# BHP Billiton Olympic Dam Development Study Addendum to the Risk Assessment

ISSUE | October 2010

This report is an addendum to the 'Olympic Dam Development Study Risk Assessment' issued by Arup in 2008, and published in the BHP Billiton Olympic Dam Expansion Draft Environmental Impact Statement (Draft EIS) as Appendix C.

Figure 2: Revised access corridor route

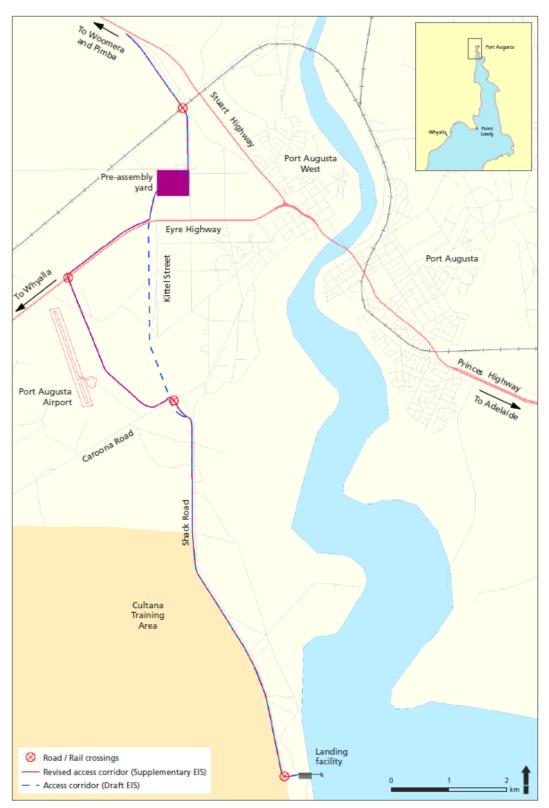
The access corridor from the landing facility to Port Augusta is to be realigned as seen in Figure 2.
